Report for: Record of Decision Taken Under Delegated Authority

Title: The Bank N6 – Proposed Traffic Management Amendments

The Bank N6 Proposed Traffic Management Amendments

The Bank N6 - Proposed Traffic Management Amendments

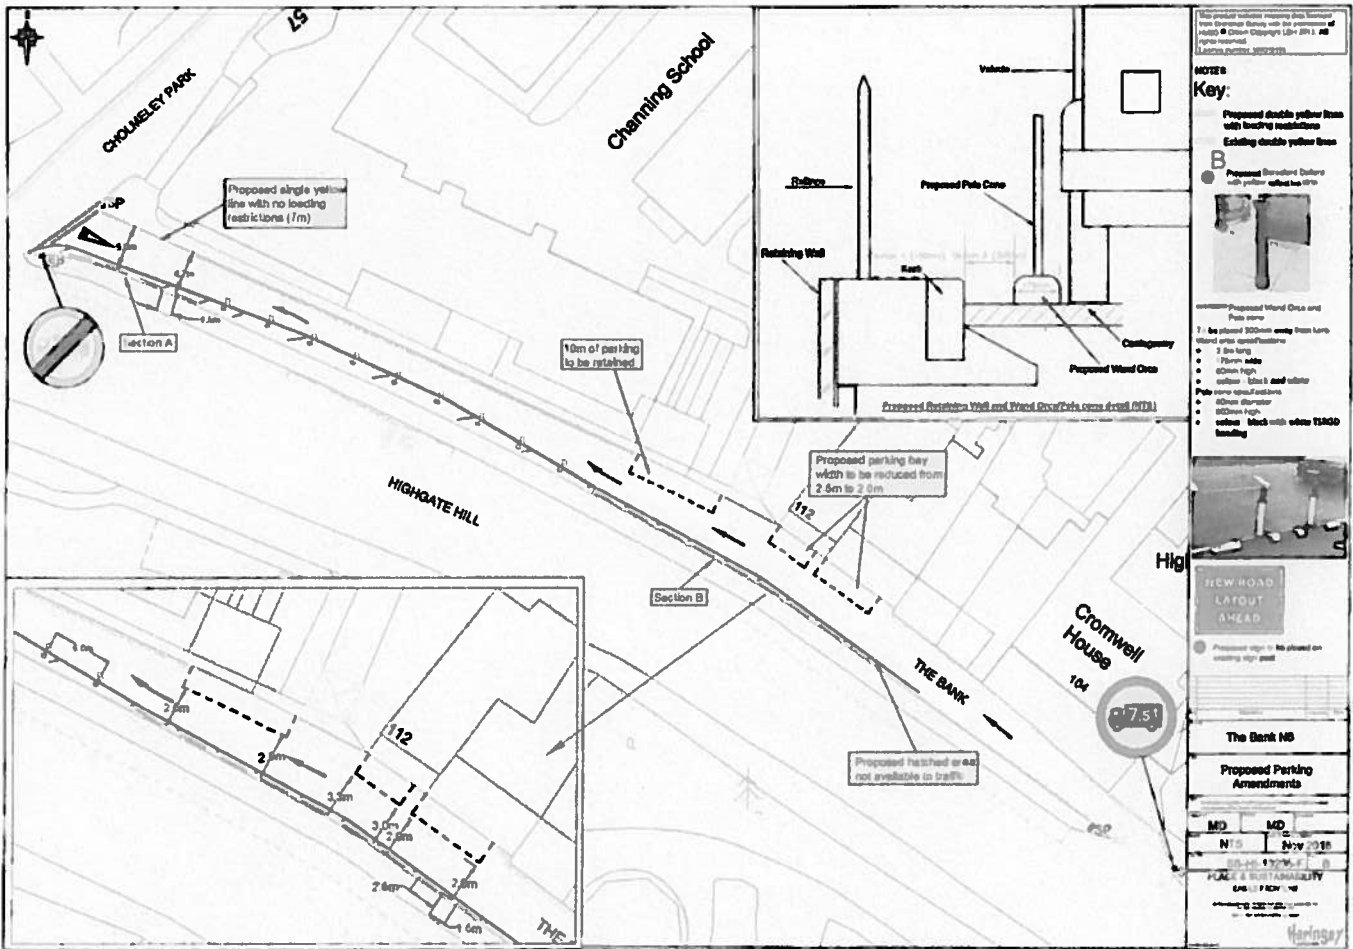
The Haringey Cycling Campaigns (HCC) and a resident are objecting to the removal of the existing cycle contra-flow along The Bank. The HCC's view is that the proposed road widths should be acceptable and the reduction in car parking will

Concerns have been raised regarding the proposed weight restriction and how it will be applied. Both Channing school and other properties along The Bank may require a vehicle over 7.5t to access The Bank, for essential building works.

A respondent is objecting to the proposed loading bay at the top of The Bank, and suggests that it should be parking.

A respondent is objecting to the proposal to narrow the first few bays on The Bank, as there's no structural issue at the bottom end of The Bank to justify this.

A resident is objecting to the introduction of bollards in the middle section of The Bank and suggests that the less obtrusive orca and poles would be a more suitable alternative.

The council is committed to improving conditions for cyclists to encourage the uptake of this sustainable transport mode. Regrettably, on this occasion we are unable to retain the cycle contra-flow along The Bank due to the narrow road widths available and also the sharp railings which could pose a danger to cyclists if cyclists decide to cycle next to the railings. Nevertheless, we intend to progress a permanent scheme at a later date following further discussions with English Heritage, the local community and subject to funding availability, at which time cycle provision will be explored.

The Traffic Order for the 7.5t weight restriction will include an exemption for building works. It should also be noted that waste removal etc is permitted.

The council is proposing 7m of single yellow line with no loading restrictions at the top end of The Bank. Therefore during the hours that the Highgate A CPZ is in operation (10:00-12:00), loading only will be permitted on this 7m section of single yellow line. Parking is permitted at all other times.

The height of the wall at the point where the parking bays start on The Bank is over 1.4m. Therefore, if a vehicle was to hit the kerb/railings at that point on The Bank, there's a risk that a pedestrian walking along Highgate Hill could be seriously injured, should the railings/bricks collapse from that height.

The middle section of The Bank is the highest point along the road and therefore more robust measures are required to physically force vehicles away from the wall/railings, as a vehicle hitting the wall/railings at this point is likely to cause a more serious accident. It should also be noted that at this point there is a bus stop below the Bank, on Highgate Hill.
